Monitoring Report – MY6
FINAL VERSION
Lake Wendell Mitigation Project
Calendar Year of Data Collection: 2023

NCDEQ DMS Project Identification # 97081
NCDEQ DMS Contract # 6826
Neuse River Basin (Cataloging Unit 03020201)
USACE Action ID Number: SAW-2016-00876
NCDEQ DWR Project # 2016-0385 V2
Johnston County, NC
Contracted Under RFP # 16-006477
Data Collection Period: March & October 2023
Submission Date: December 29, 2023

RE: WLS Responses to NCDEQ DMS Review Comments for Task 12 Draft Monitoring Report Year 6 for the Lake Wendell Mitigation Project, NCDEQ DMS Full-Delivery Project ID #97081, Contract #6826, Neuse River Basin, Cataloging Unit 03020201, Johnston County, NC

Figure 4: Monthly Rainfall Data
Lake Wendell Mitigation Project (NCDEQ DMS Project ID# 97081)
MY6 2023

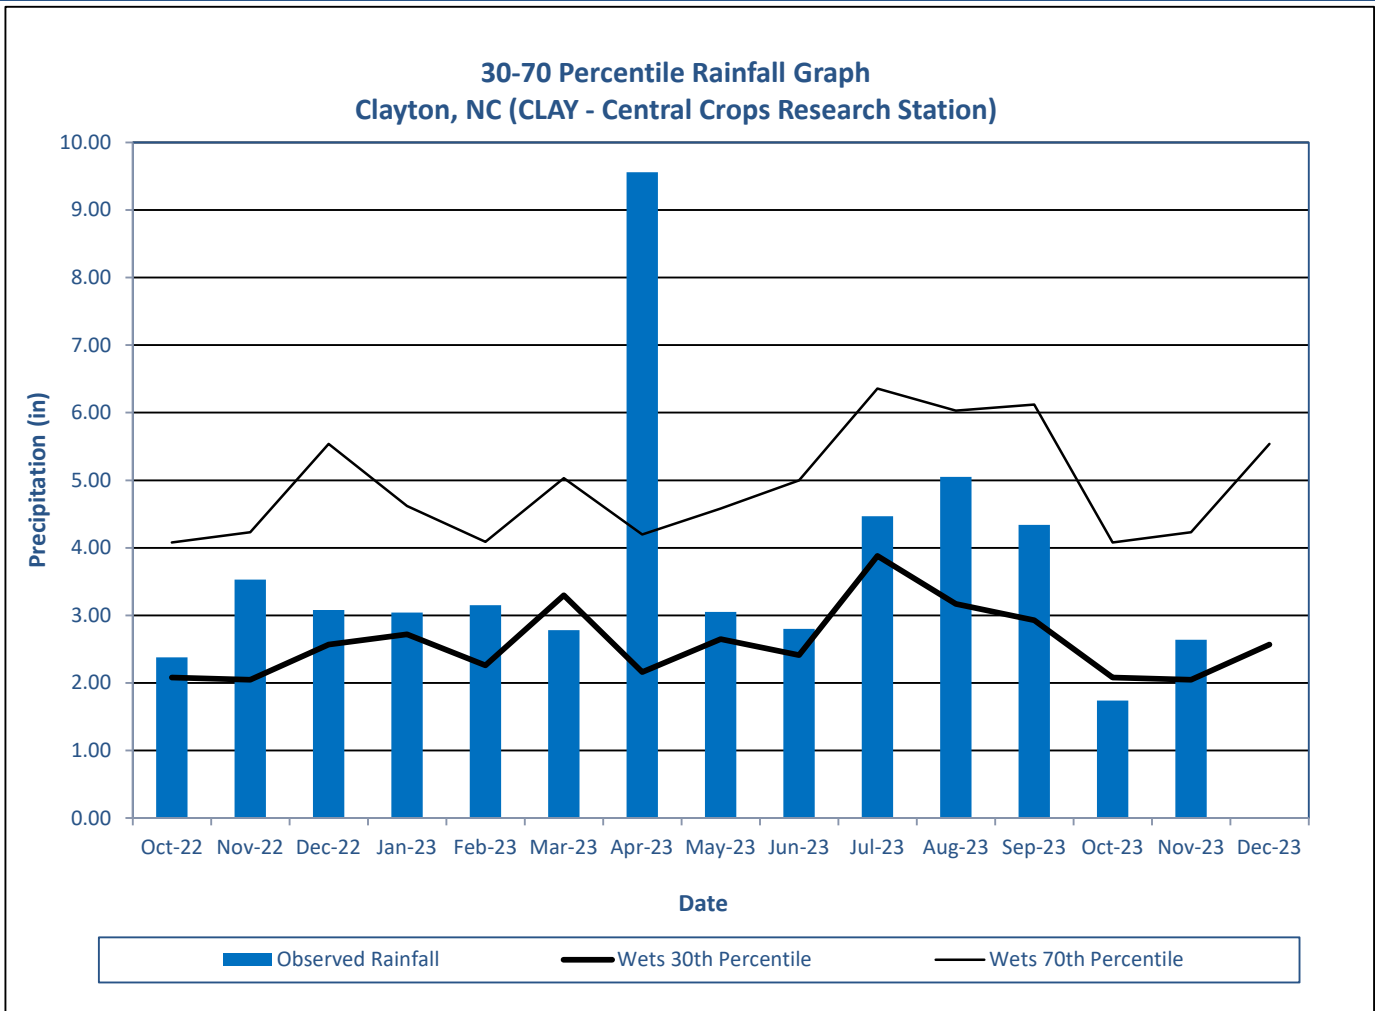
- 4. Appendix D, Figure 4: Please update with rainfall through November if possible.** WLS Response: Rainfall through November 2023 has been updated in the Appendix D Rainfall Table.
